**CHANGE ORDER PROPOSAL NO.: 4**

**PROJECT:** Bethel PD Training Range

COP #004 - Cutting and Patching Roof for Anchor Installation

TRAINING RANGE CHANNEL STRUT PLAN

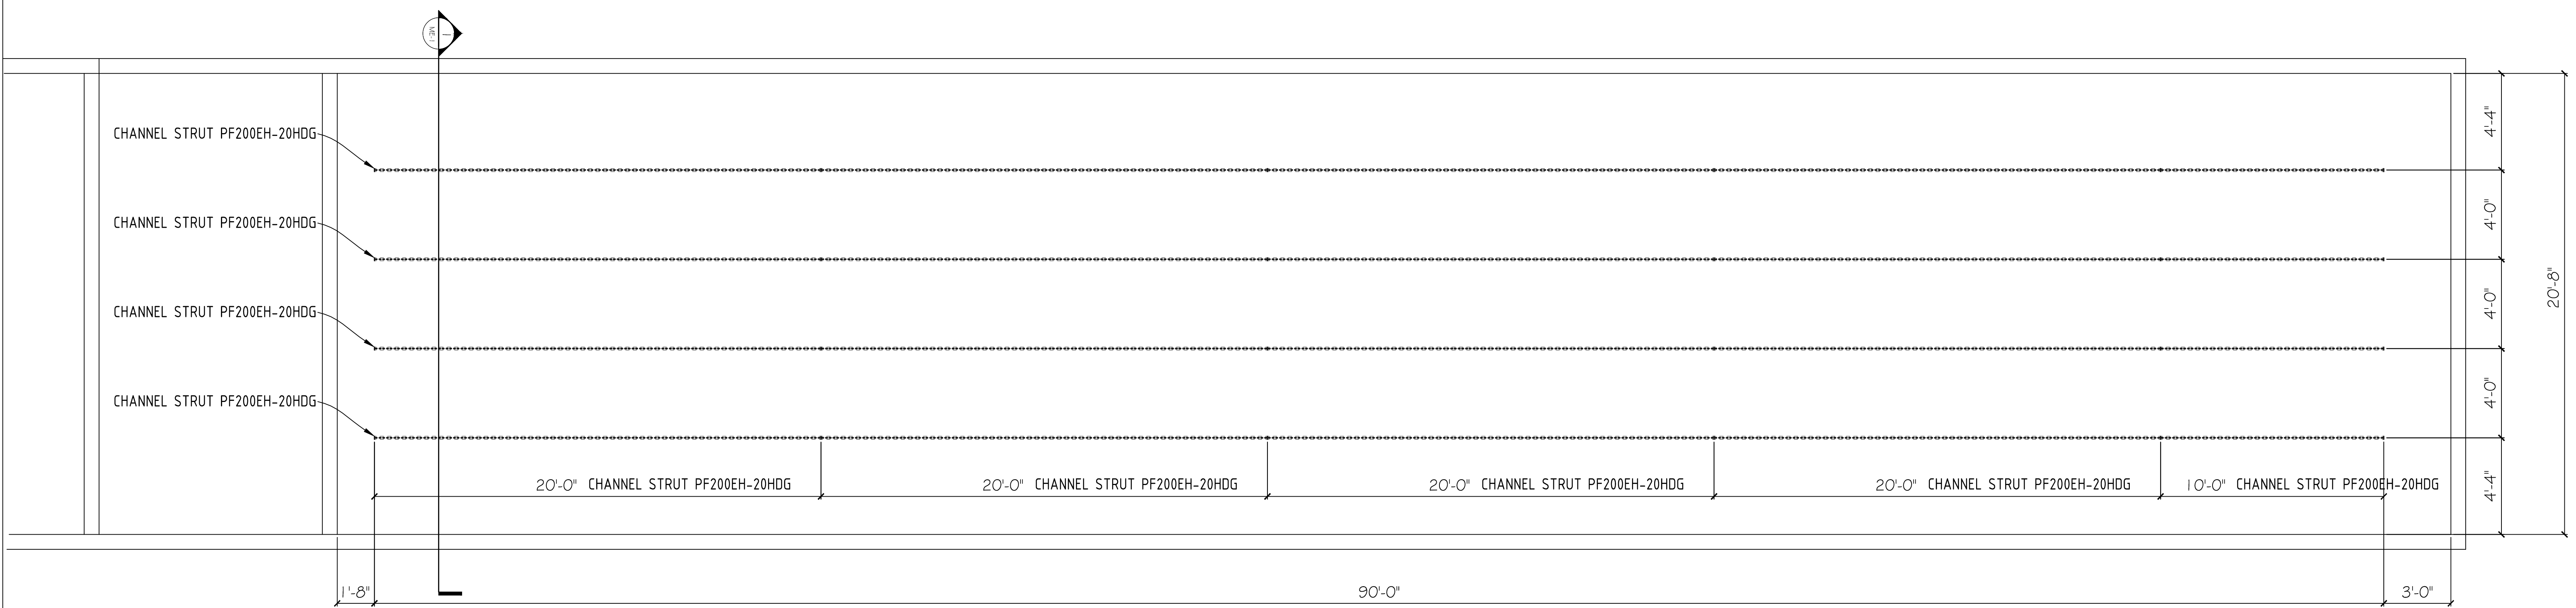
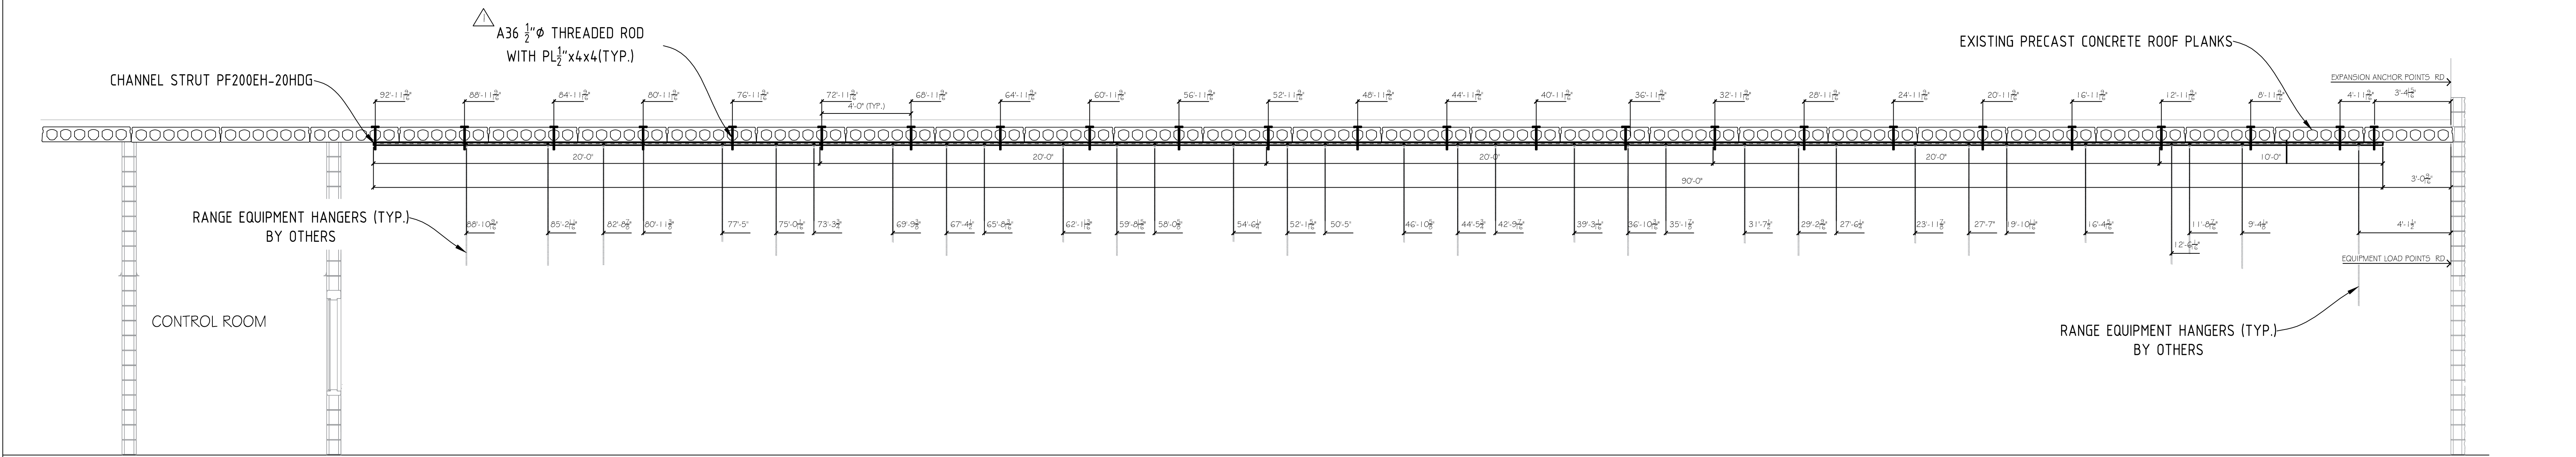
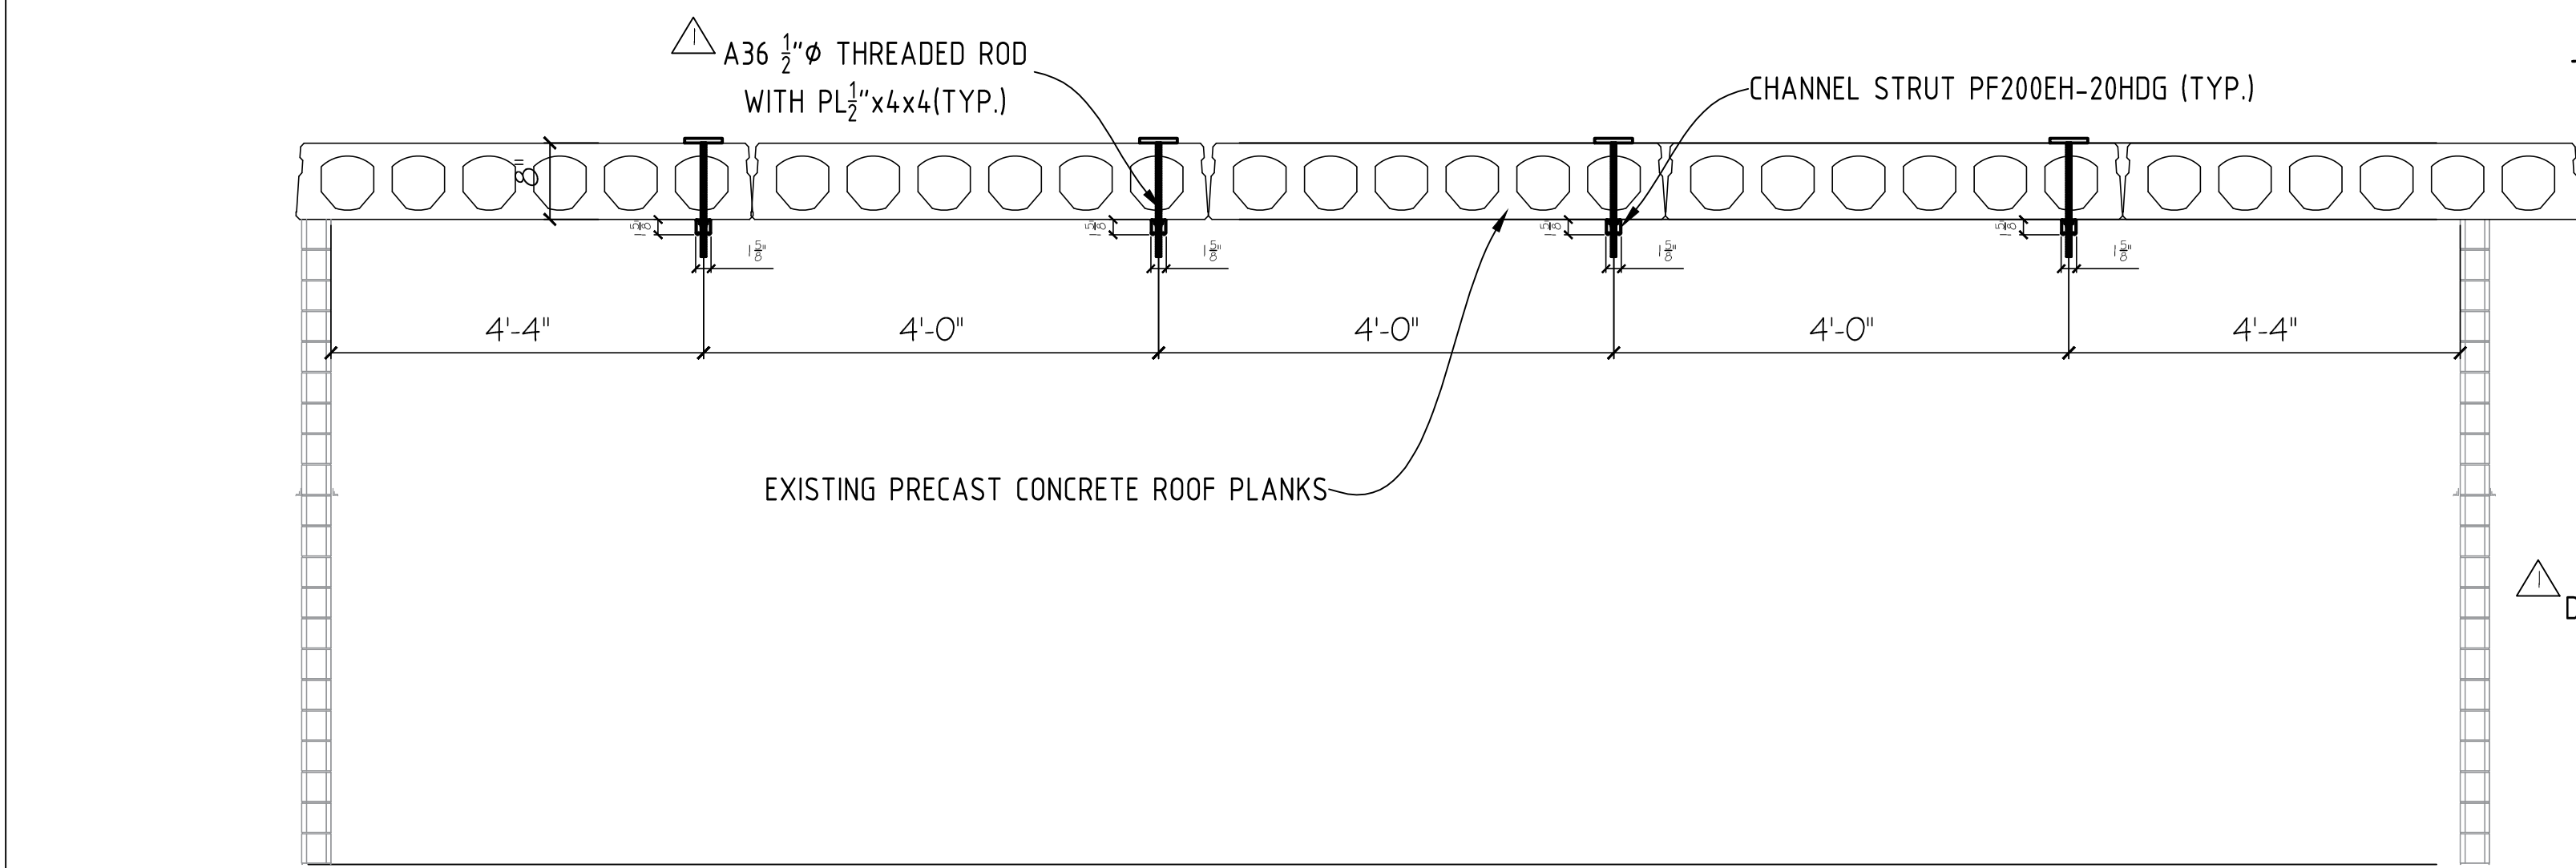
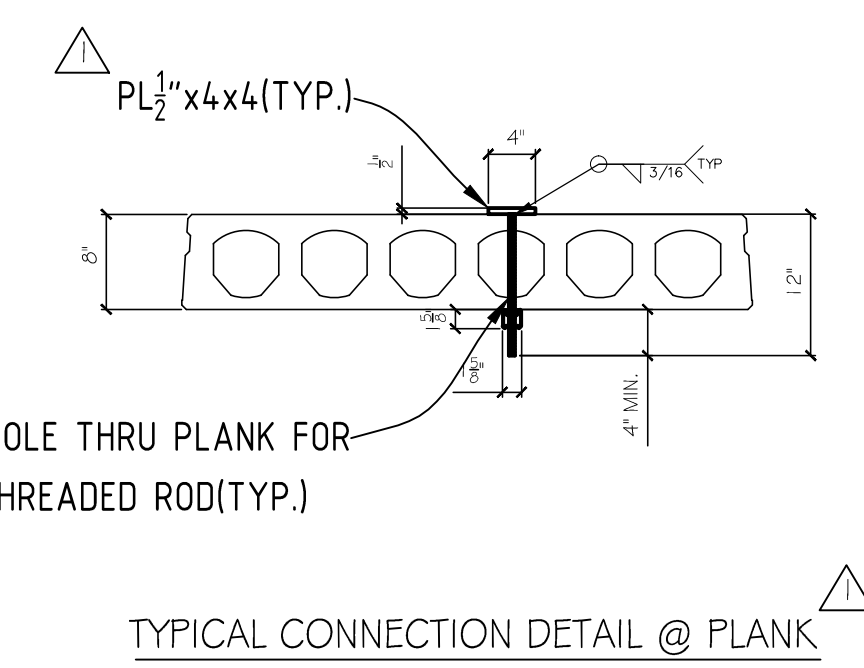
The original method of drilling and installing epoxy anchors into the hollow precast ceiling planks was determined by an engineer to not be acceptable for supporting the weight of Action Target's ceiling mounted equipment. A new method, using a through bolt anchor, was proposed and accepted in RFI #005. Per the engineered drawing, there are (96) locations where anchors need to be installed. To facilitate the installation of these anchors, sections of the existing roof membrane, rigid insulation and roof board need to be cut and patched. Greenwood Industries was the original roof installer, and they will maintain the existing NDL warranty.

Downes was notified by the Unistrut engineer that the existing precast roof panels are not thick enough for a post-installed anchor to support the Action Target equipment - see attached email. An Oldcastle detail was provided (also attached), showing a through bolt anchor. This would require drilling through the precast panels, and cutting and patching the roof membrane.

Provide proposal to furnish and install anchors as detailed, including anchor layout and calculations signed and sealed by a Connecticut Registered Engineer, roof patching and credit for material and labor installation of slotted channel supports.
